Re: Turkey Point Units 3 and 4
Docket Nos. 50-250 and 50-251
Response to NRC Request for Additional Information Regarding
Extended Power Uprate License Amendment Request No. 205 and
Reactor Systems Issues

Turkey Point Units 3 and 4
RESPONSE TO NRC RAI REGARDING EPU LAR NO. 205
AND SRXB REACTOR SYSTEMS ISSUES

2.8.5.1.2 Steam System Piping Failures Inside and Outside Containment

Figure SRXB-LR 2.8.5.1.2J-1
Steam System Piping Failure at Hot Zero Power – 0.9 ft² Split Break
with Offsite Power Available and with Accumulator Boron Credited
Nuclear Power and Core Heat Flux vs. Time

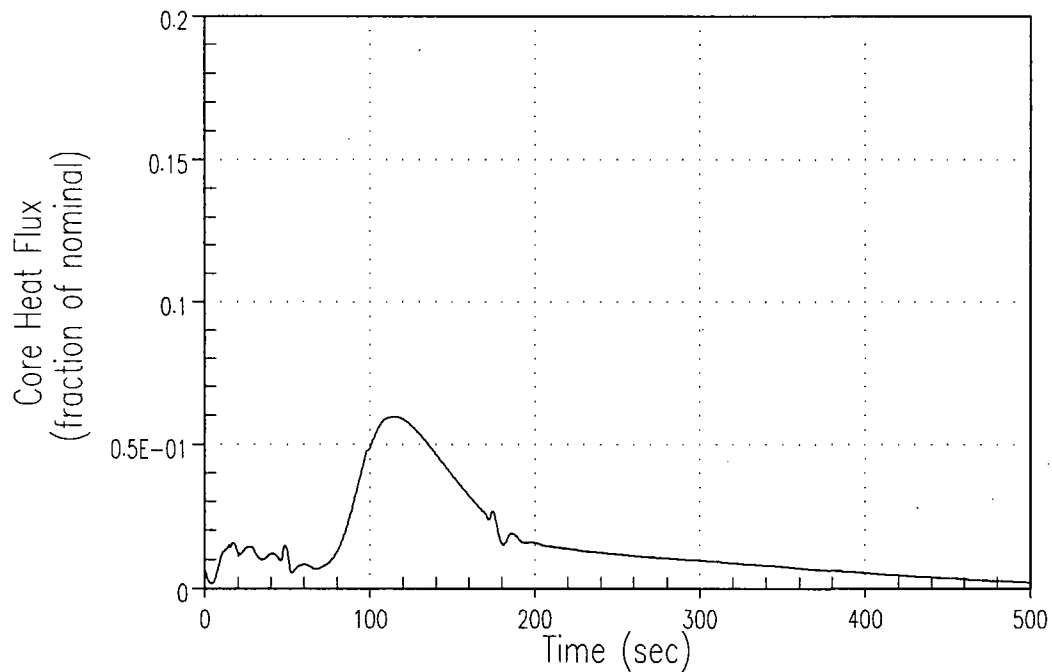
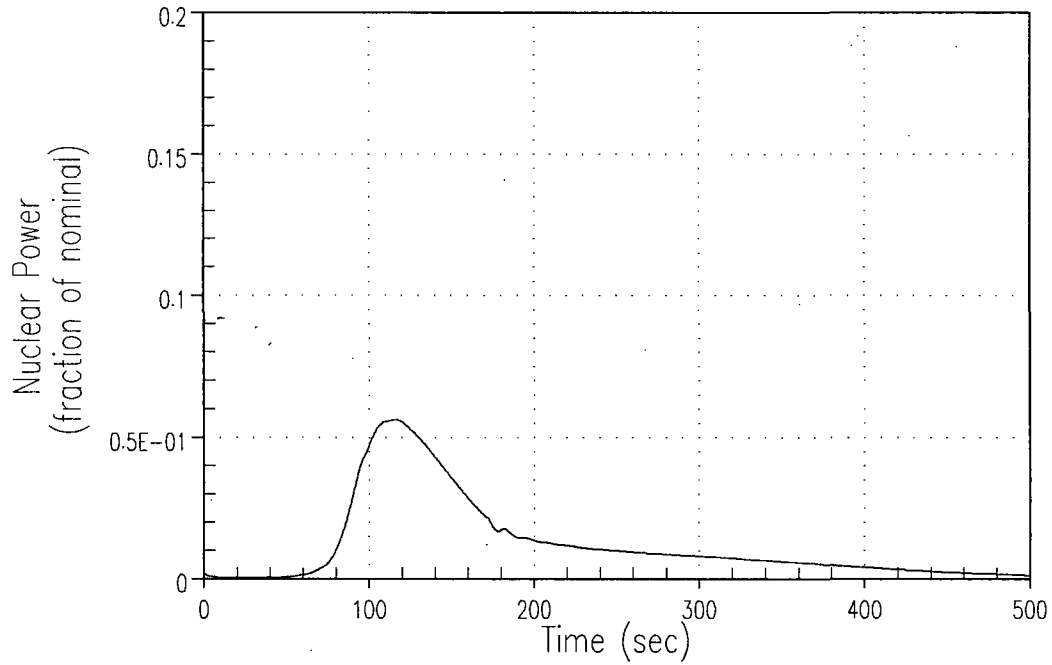
2.8.5.1.2J Minor steam line breaks ($< 1.4\text{ft}^2$) are said to be bounded by the major steam line break. Show that there is no minor break, larger than a credible break; but too small to cause steam line isolation, that is not bounded by the major steam line break.

A comparison of the sequence of events for each of the analysis cases examined is provided in Table SRXB-LR 2.8.5.1.2J-2; the transient plots for the analysis of a 0.9 ft² split break on the main steamline with minimum accumulator boron credited are provided in Figures SRXB-LR 2.8.5.1.2J-1 through SRXB-LR 2.8.5.1.2J-8.
